ADDENDUM NO. 1

PROJECT NAME: Wick Alumni Center Life Safety & HVAC Improvements
UNL PROJECT NUMBER: C120P021
BID INVITATION NUMBER: 2222-13-7200

CONSULTANT: Farris Engineering
ADDRESS: 818 P Street, Suite 100

DATE OF ISSUANCE: September 3, 2013
DATE OF BID OPENING: September 18, 2013

METER ROOM 028 HVAC PIPING DEMOLITION SCHEMATIC
NO SCALE

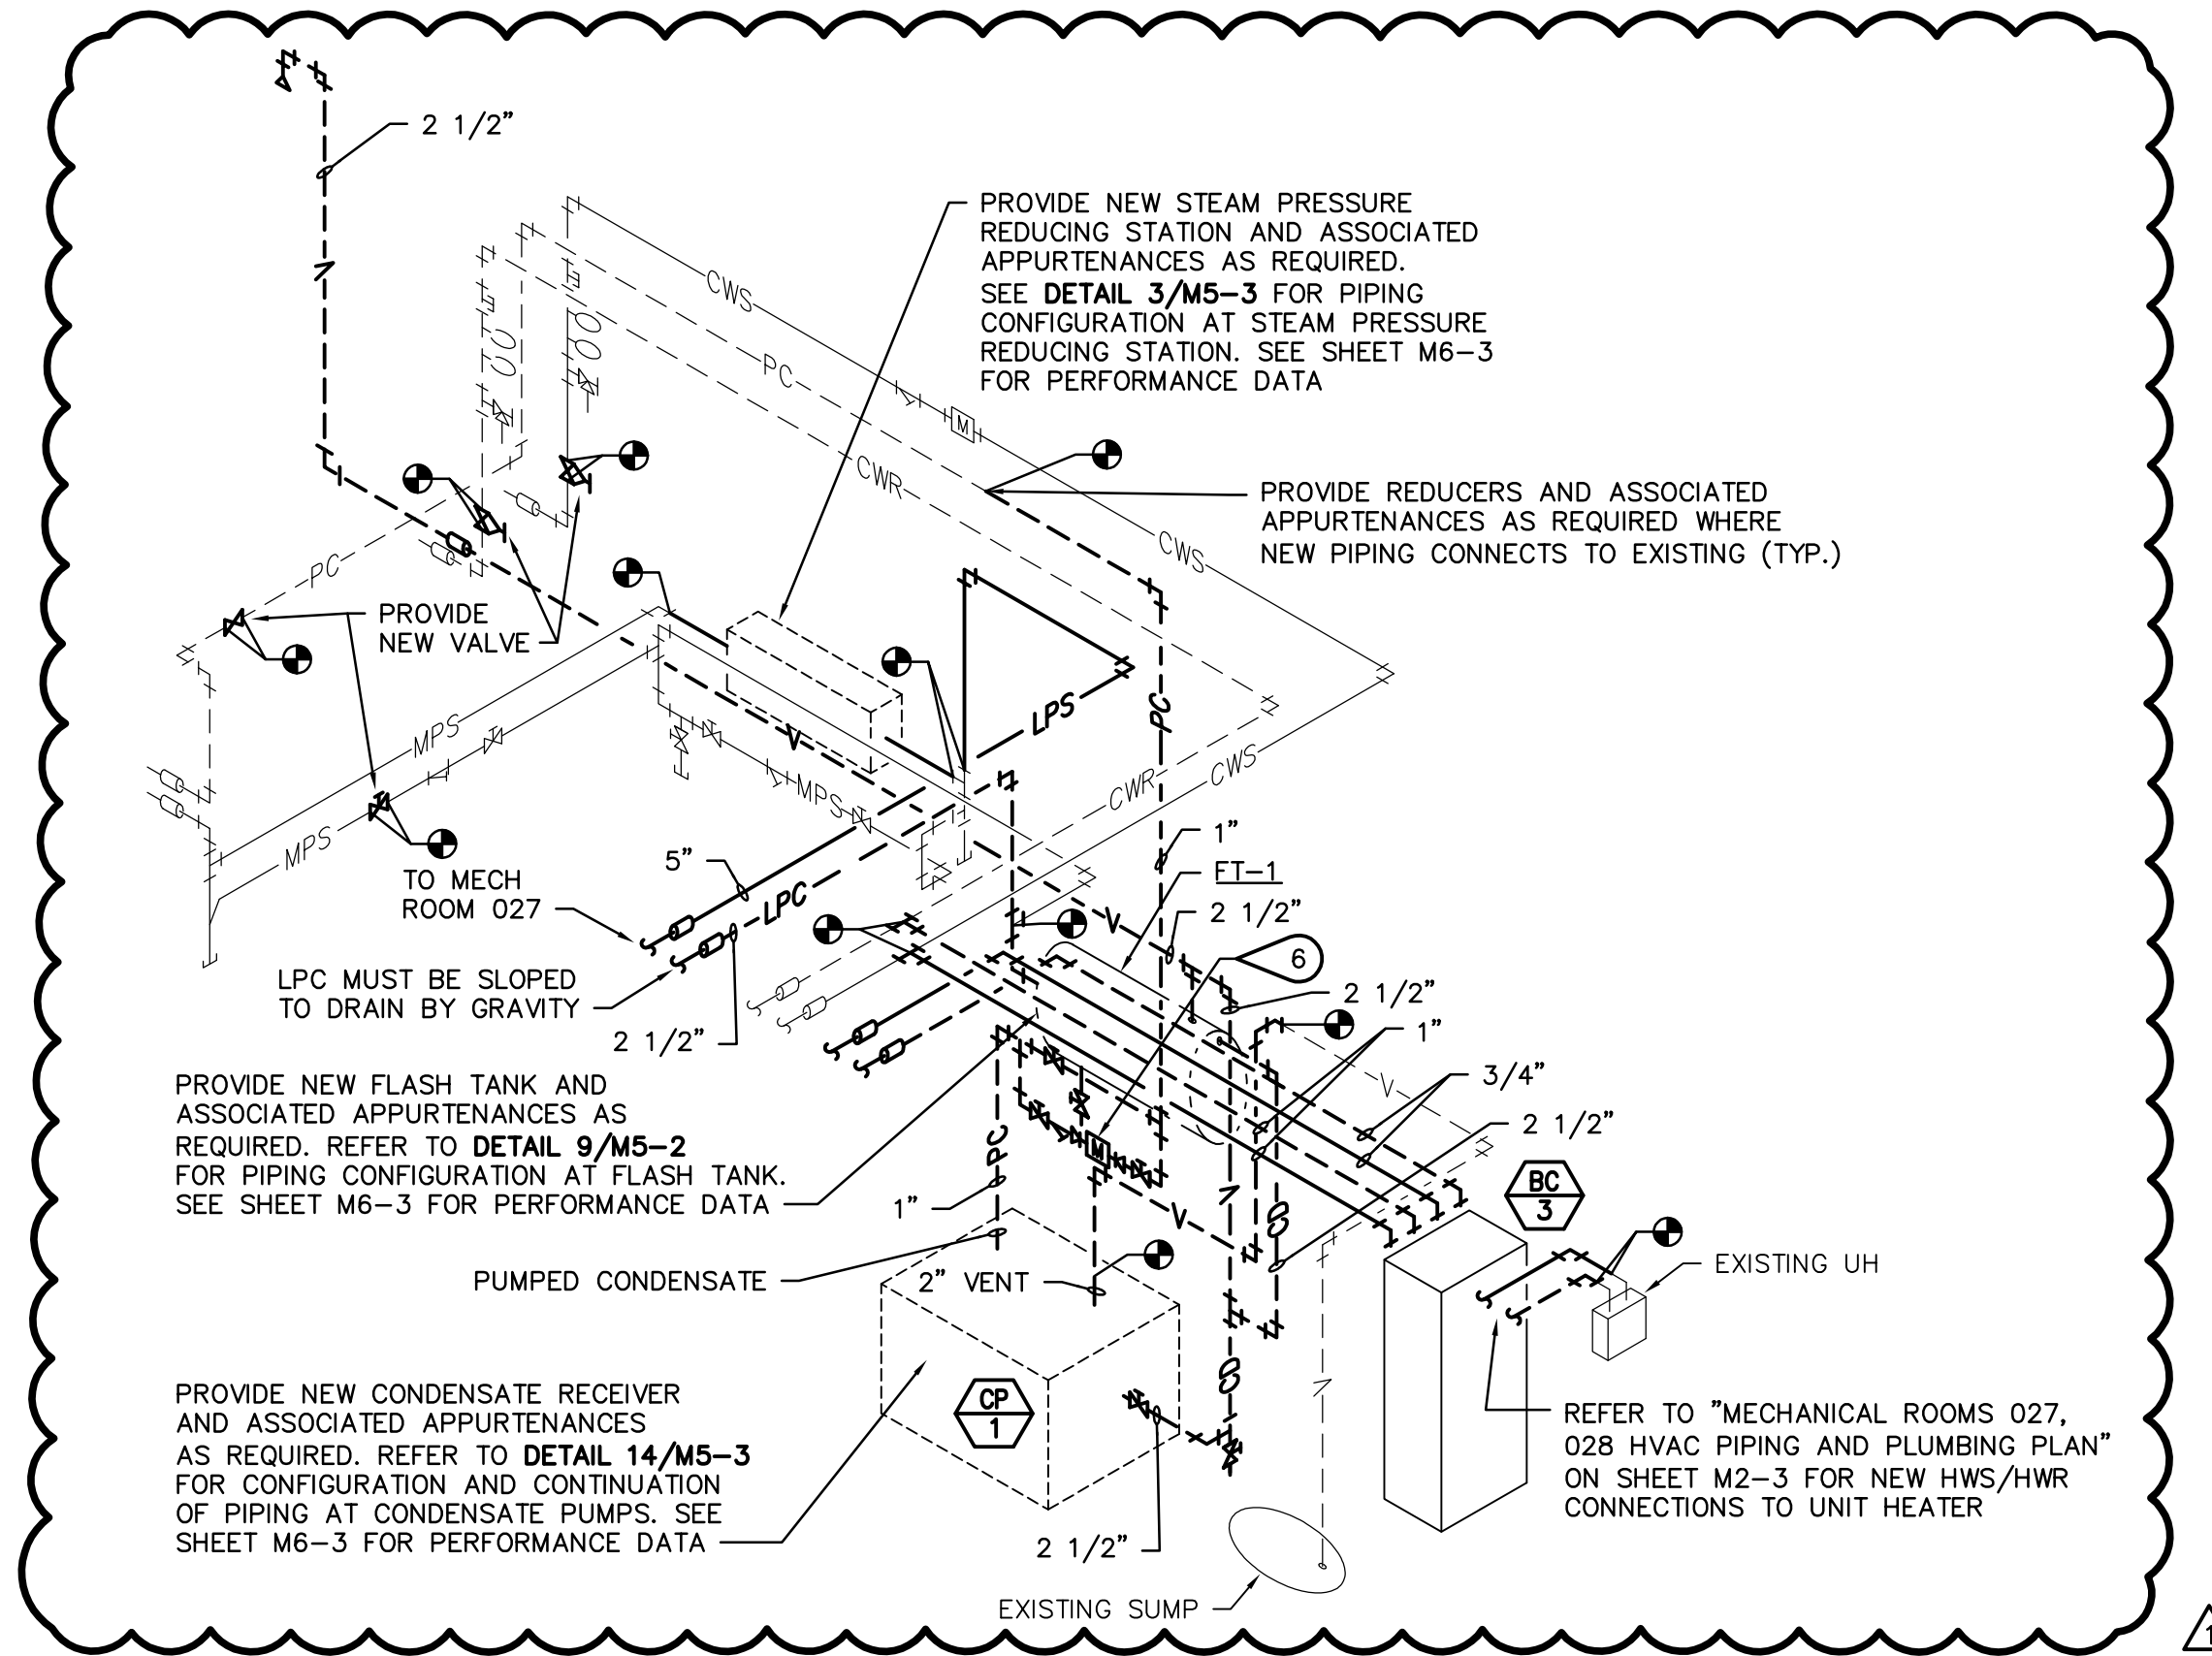
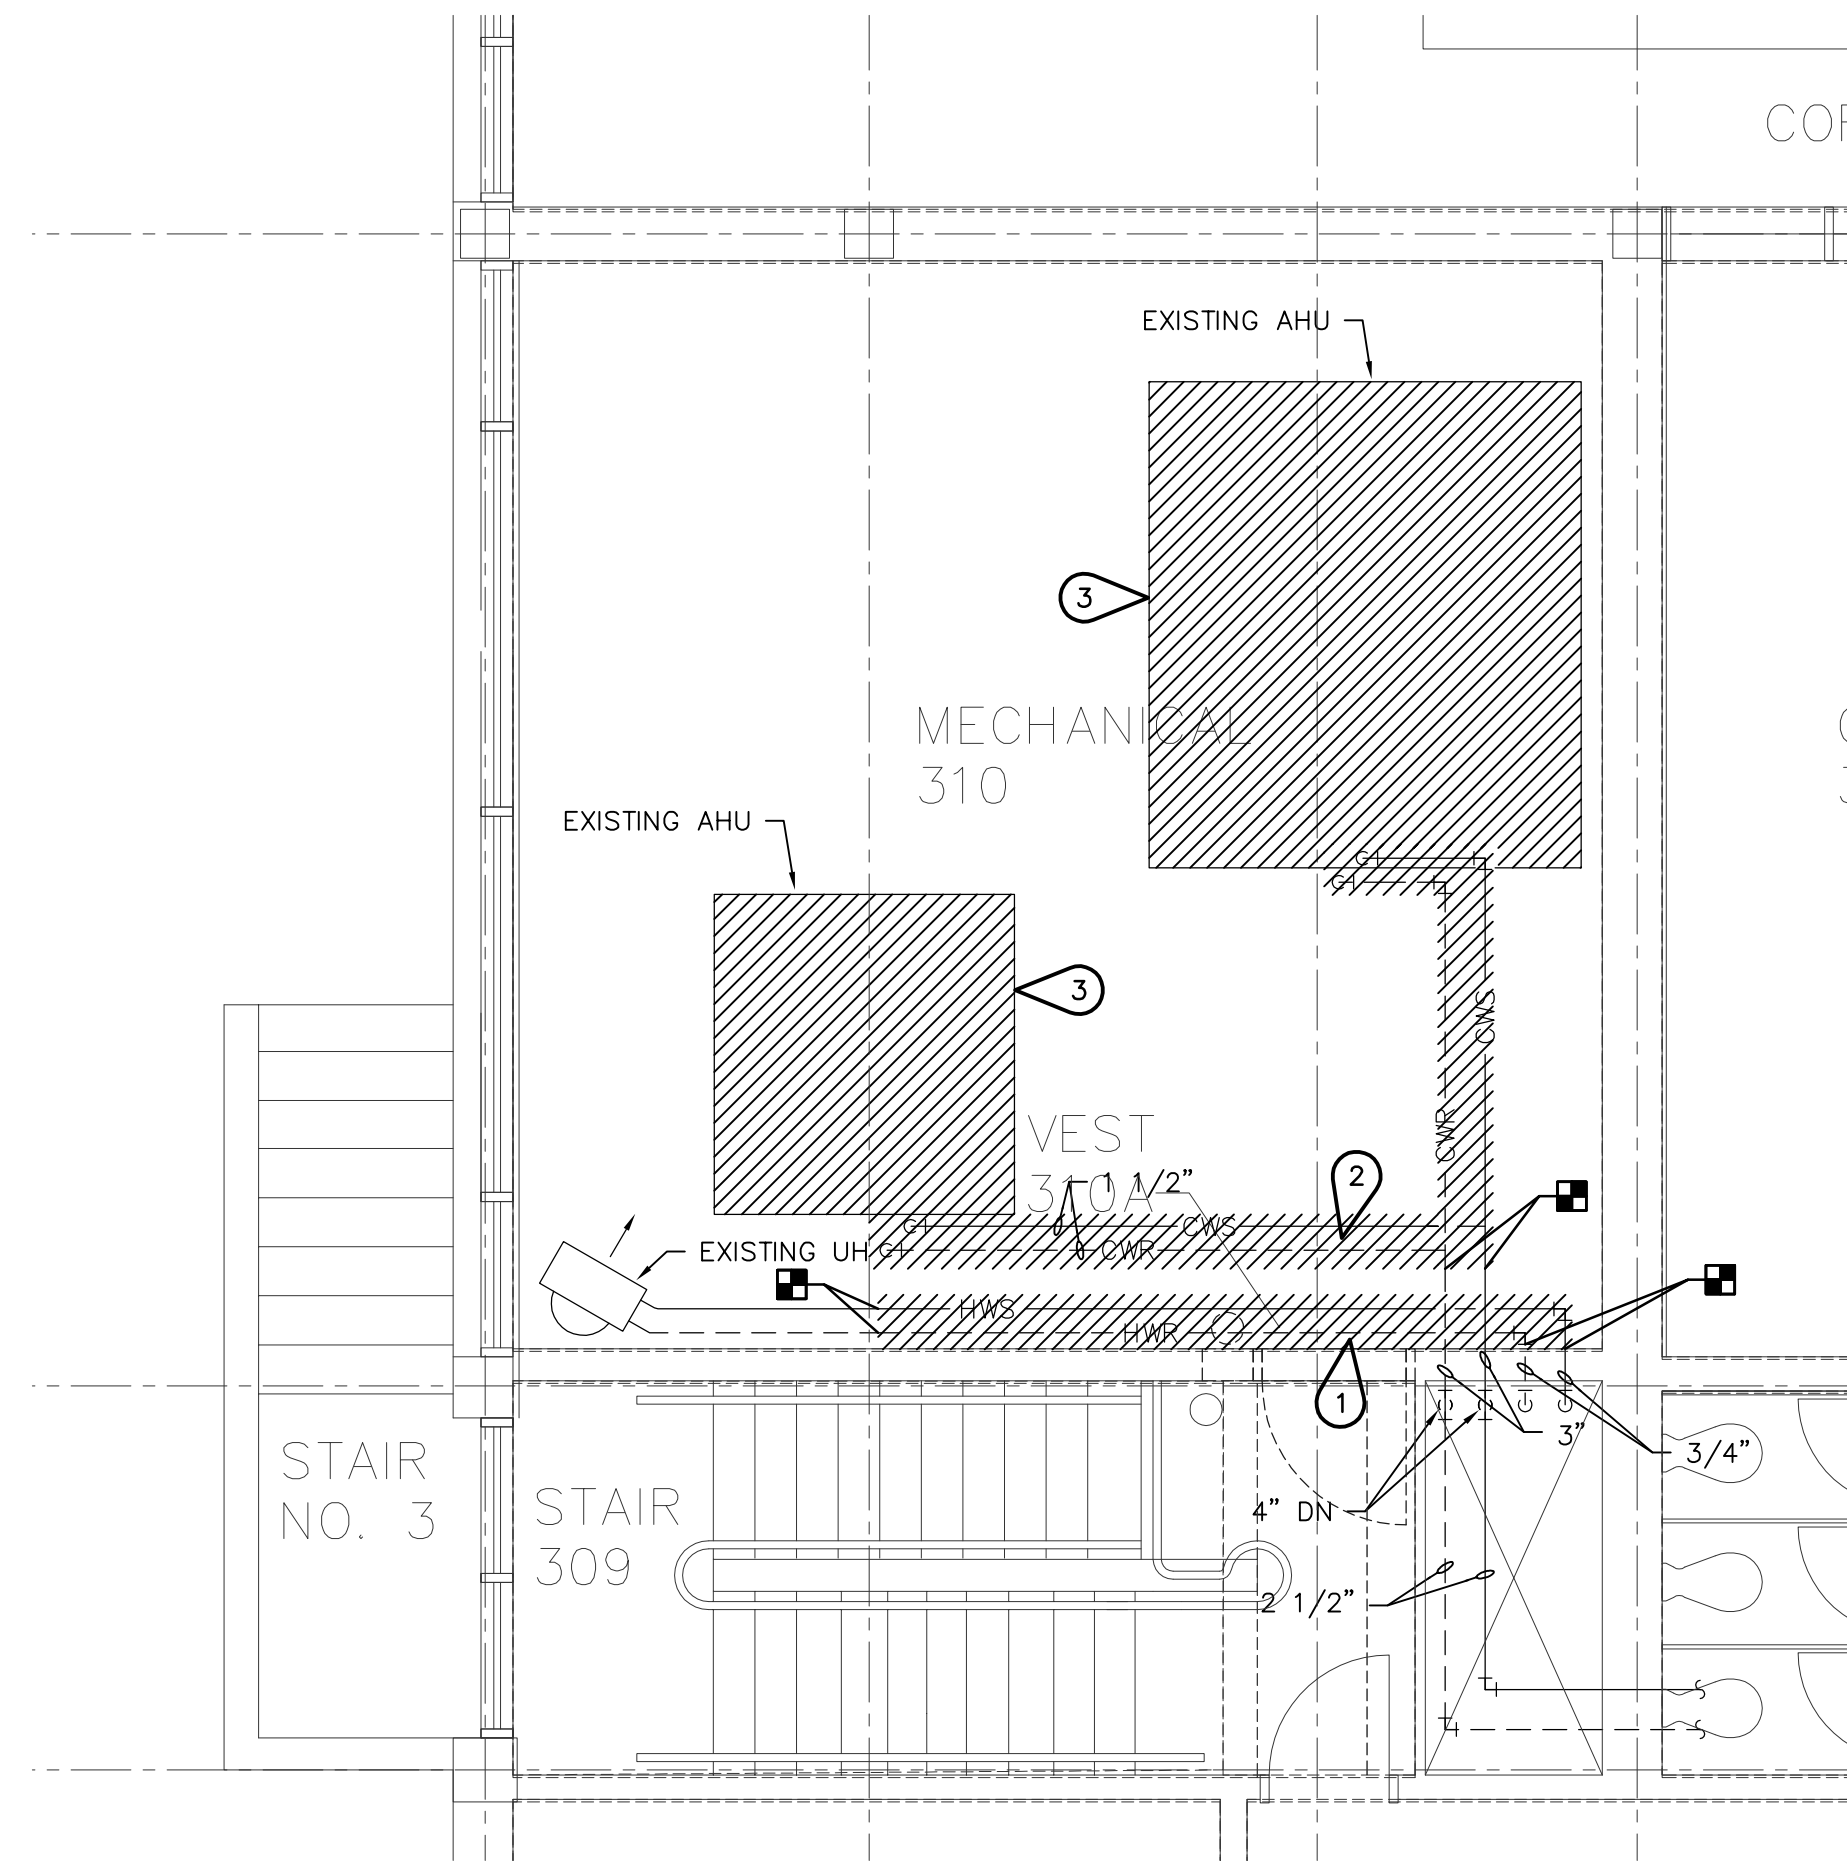
- B. "METER ROOM 028 HVAC PIPING DEMOLITION SCHEMATIC" has been revised.
 - C. "METER ROOM 028 HVAC PIPING SCHEMATIC" has been revised.
 - D. Mechanical Keynote #1 has been revised.
